From: Lou Miller [REDACTED]
Sent: Friday, October 02, 2009 6:46 PM
To: Chang, Richard; Cohen, Stephen
Cc: Larry Corte; Brad DeWaard; Harley Shaver
Subject: Split Rock information
Attachments: DOC005.PDF; DOC006.PDF; DOC007.PDF; DOC008.PDF

The following e-mail is intended to address questions you asked in regards to our proposed license amendment to change Se groundwater standards to the EPA MCL and to set uranium "trigger" levels at background values.

FIGURE 1
SURFACE WATER AND GROUND WATER MONITORING LOCATIONS

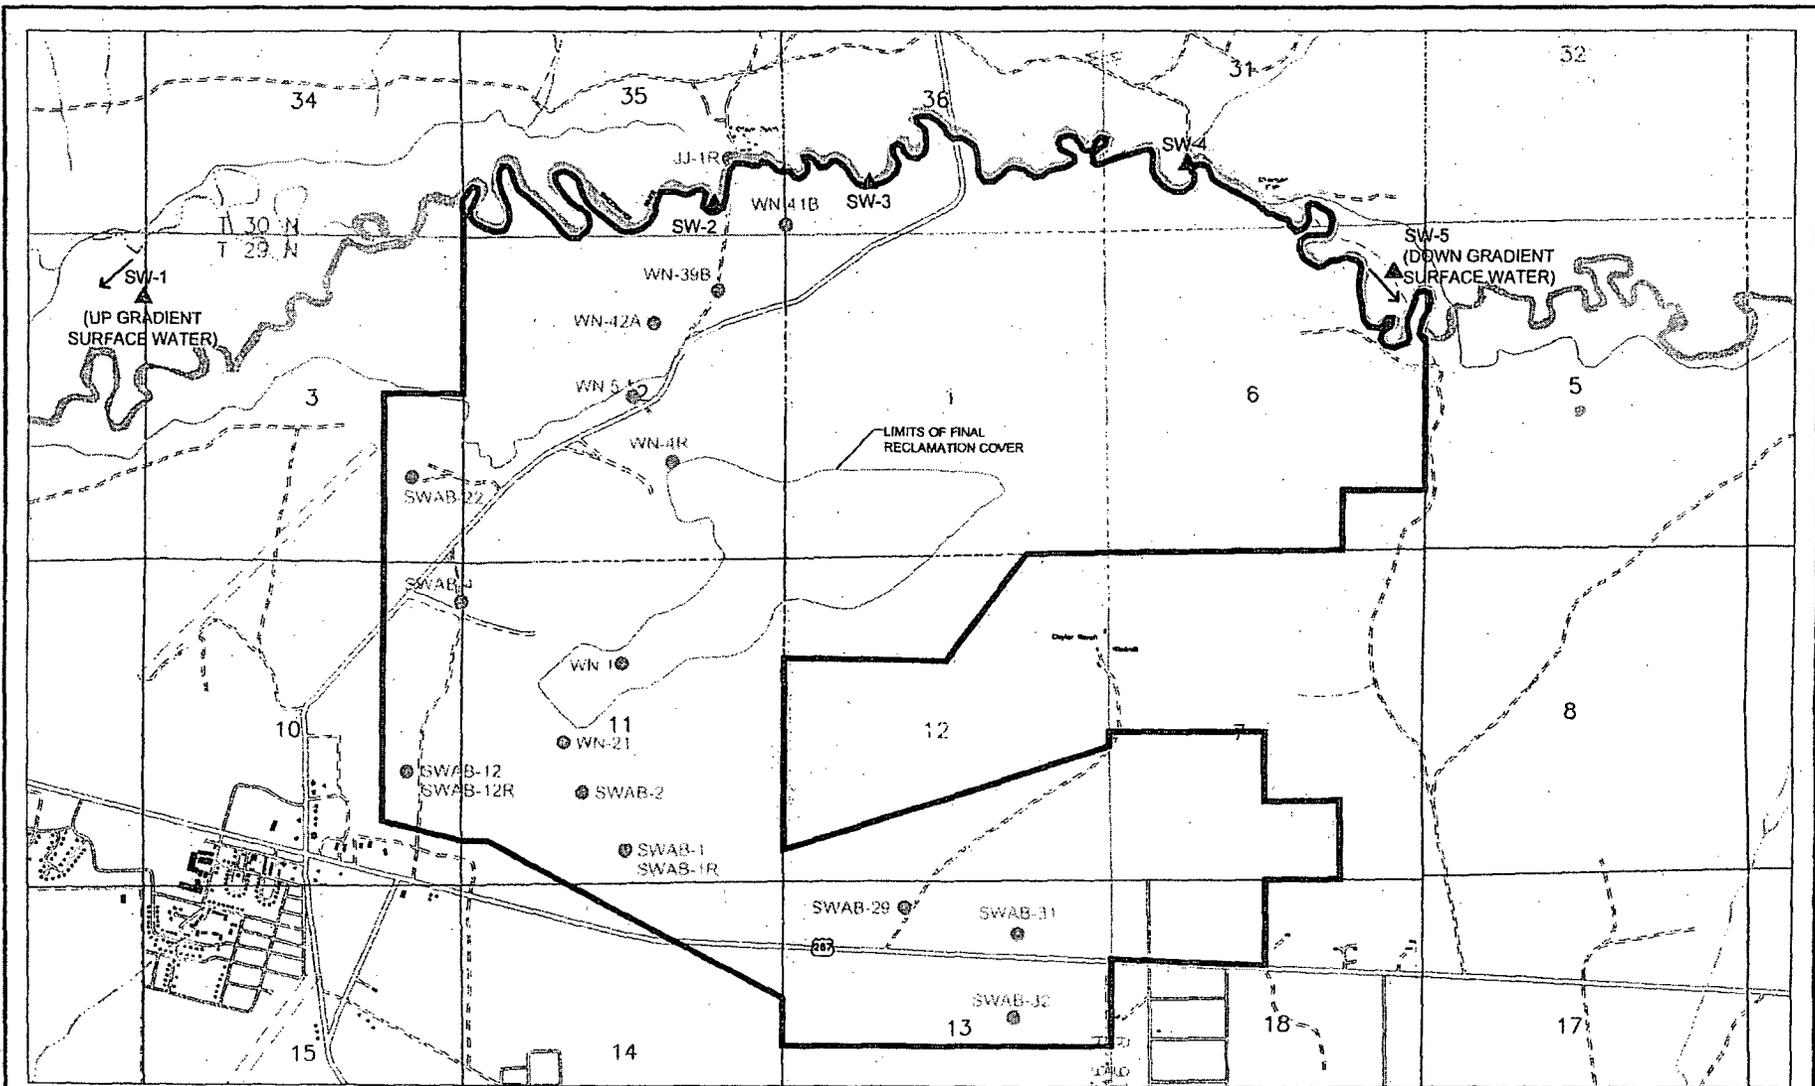
2. The attached figures show the following:
 - o The location of the existing monitoring wells and surface water points (this figure is from the monitoring report)

FIGURE 36
BACKGROUND GROUND WATER AND
SURFACE WATER SAMPLING LOCATIONS

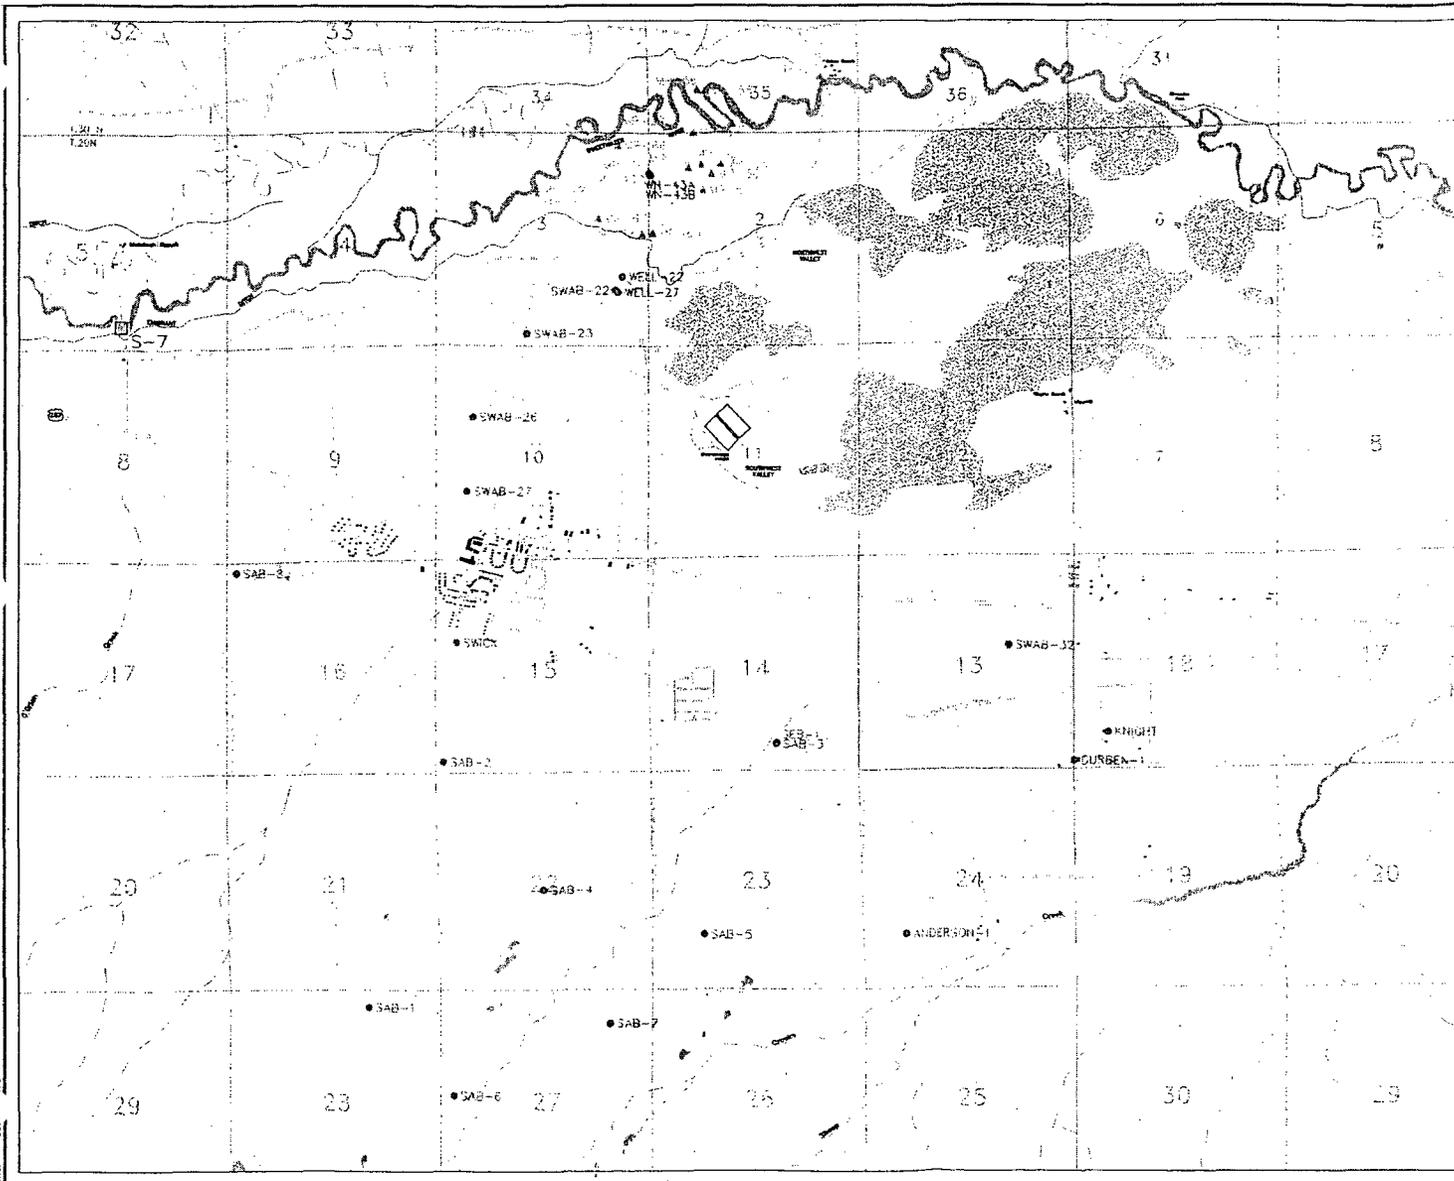
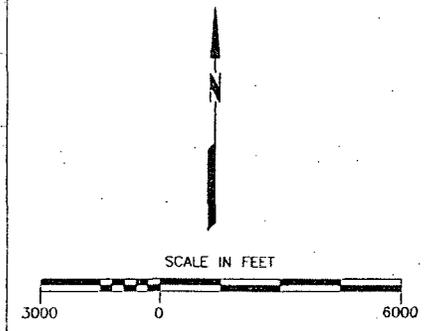
- o The location of the wells used for background (from the 1999 report)
 - o A table indicating the formation (Split Rock or Flood Plain Alluvial aquifer) that each well is completed in.

- o All of the existing monitoring wells are in the Split Rock Formation except for JJ-1R which is in the floodplain alluvial aquifer
3. You asked about predictions of selenium concentrations in the Sweetwater River. We have predicted the concentrations that might occur at a frequency of once every 10 years by using the 10th percentile flow data from the USGS Sweetwater Station (See attached figure). Flows would be less than the 10th percentile low flow values on average every 10 years and the Wyoming (and EPA standards) indicate that the chronic values should be exceeded only once every 3 years. Using low flow values that represent once every 10 years is therefore conservative.
